Denim Processing Plant Ltd

Belashahor, Chandina, Comilla-3510
(23.486273, 90.986197)

15th October 2019

Observations

Table for report on Foundation:

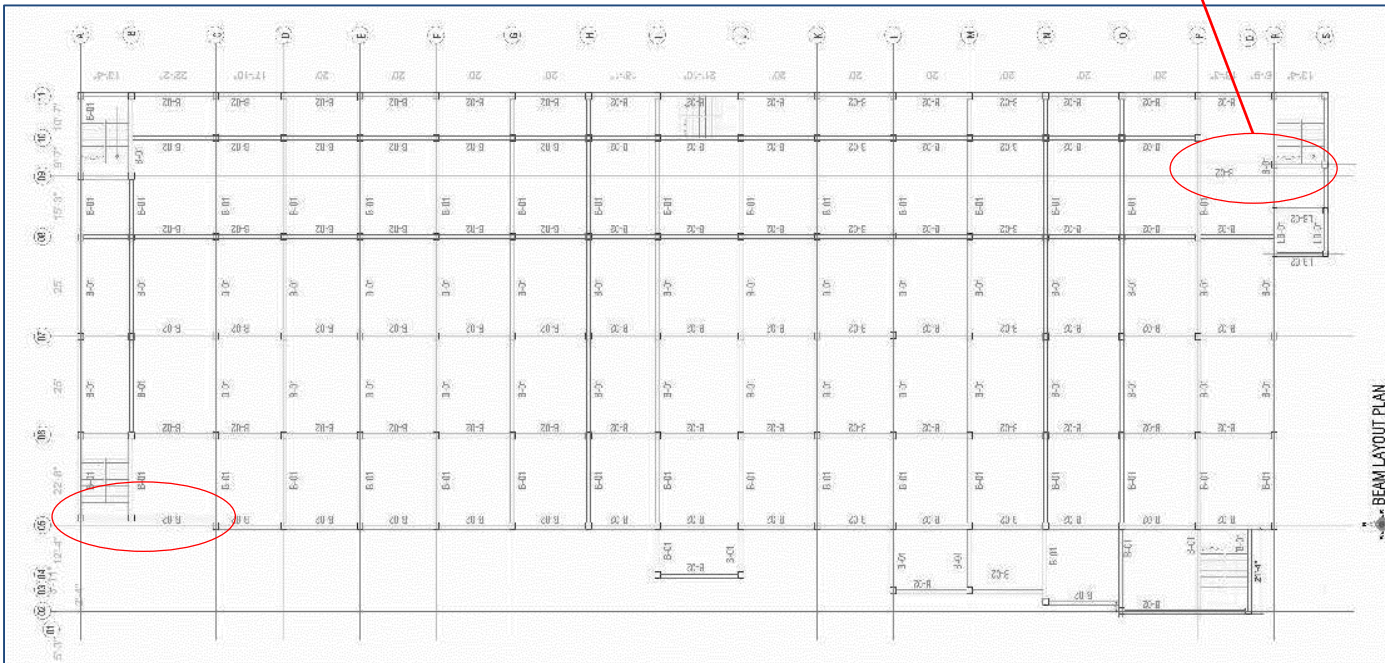
Cursory calculation indicates that the some of the foundations are stressed above design limit considering mentioned bearing capacity of soil. In design report, detail foundation adequacy check, loading information & bearing capacity calculations are not provided.

Exposed rebar on the roof

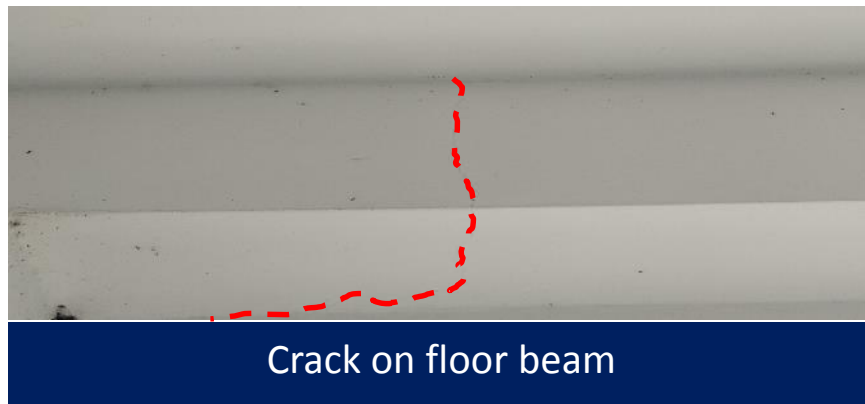
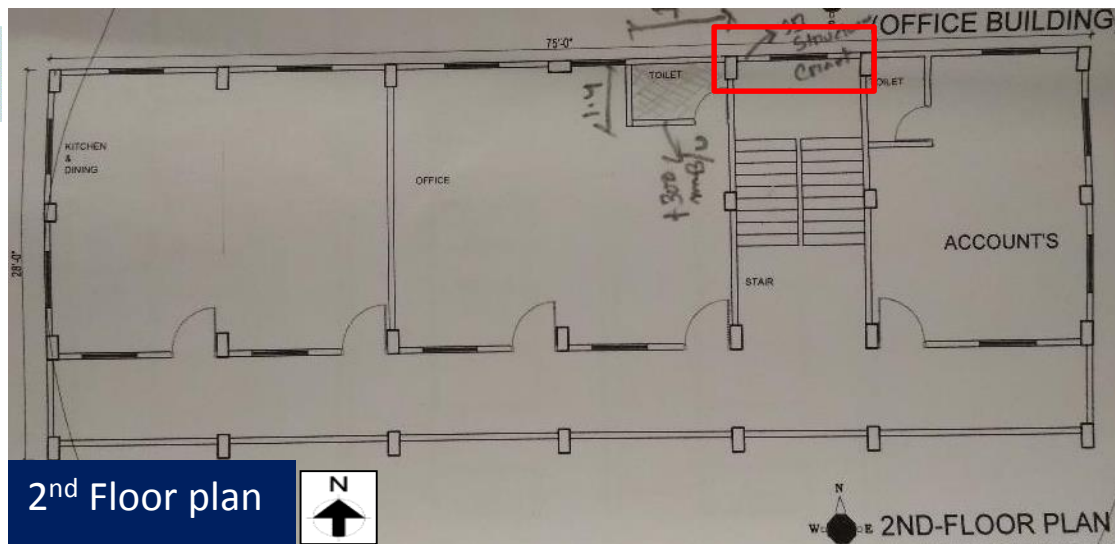
Rebar was found exposed on the roof. Factory is required to take necessary measure to protect the rebar from corrosion.

Crack on beams

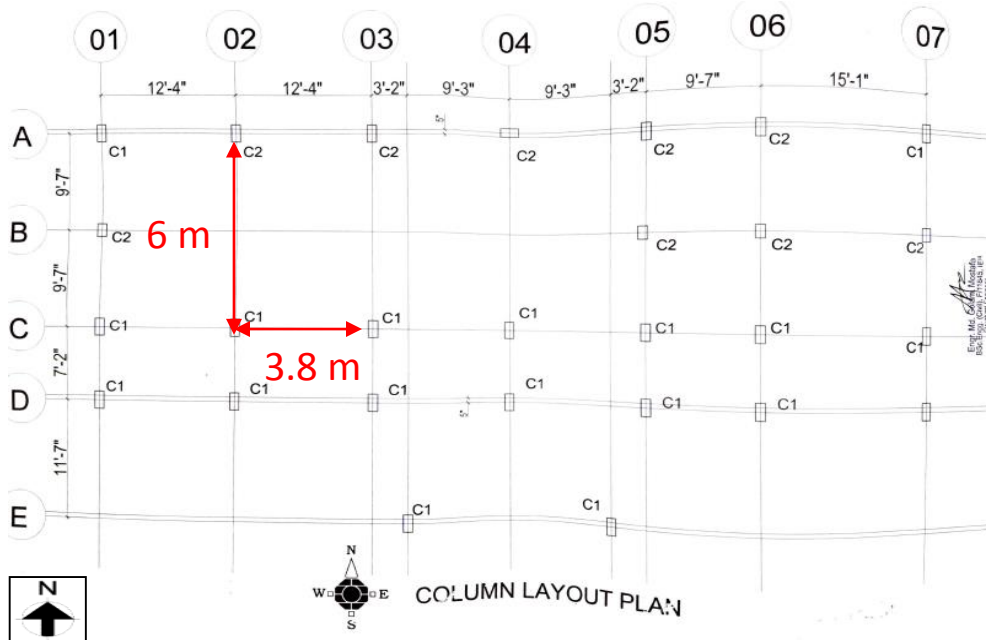
Cracks were observed on floor beams. Building engineer is required to investigate the cracks and carry out suitable repair work as per recommendation of investigation report. Provide temporary prop support to the cracked stair beam until further investigation and completion of remediation.
